IMPORTANT SAFETY RECALL NOTICE: 16V-569

Pneumatic Shift Unit Clevis Pin Retrofit Kit Instructions NHTSA Recall 16E059

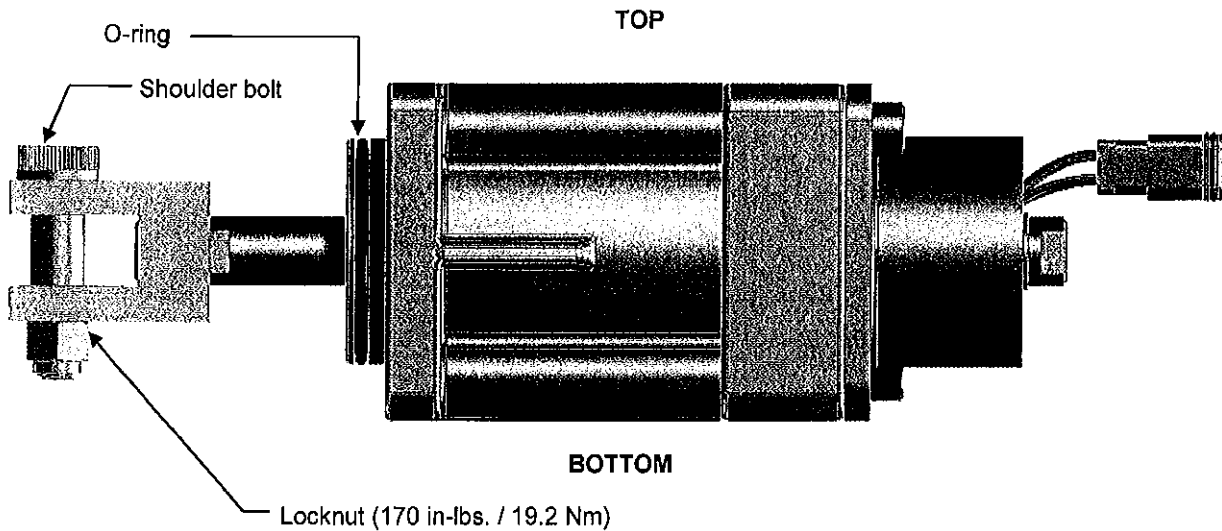
8. Remove one retaining ring from the clevis pin and remove pin as shown below.

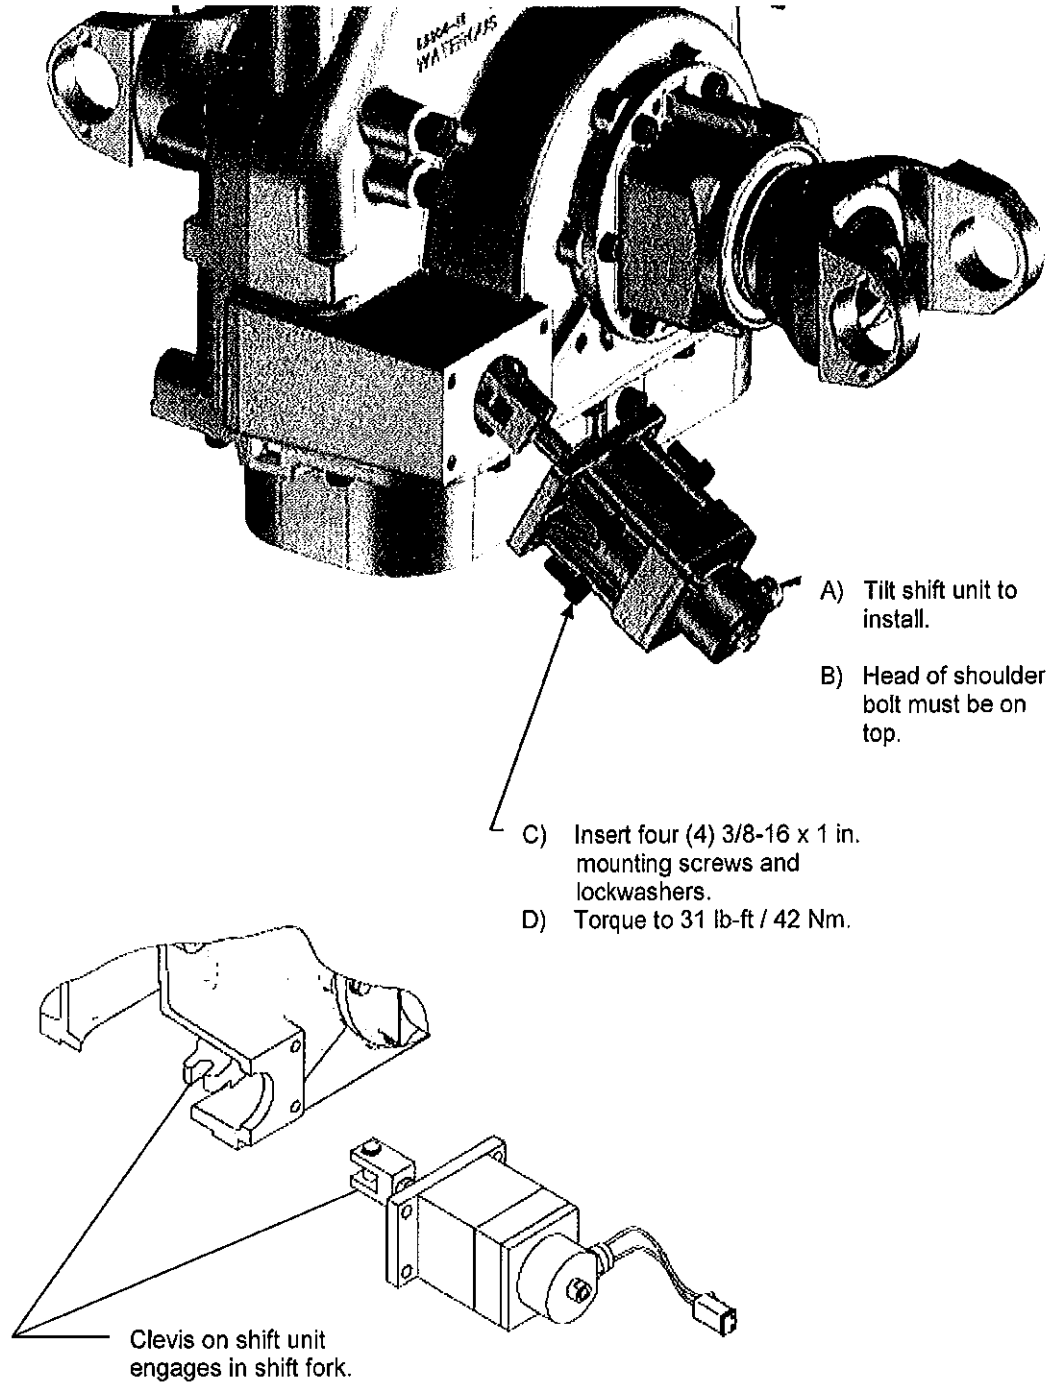
9. Remove and replace shift unit O-ring, coating O-ring with grease upon replacement.
10. Install shoulder bolt and locknut as shown below. Head of shoulder bolt must be on top. Torque to 170 inch-lbs. / 19.2 Nm.
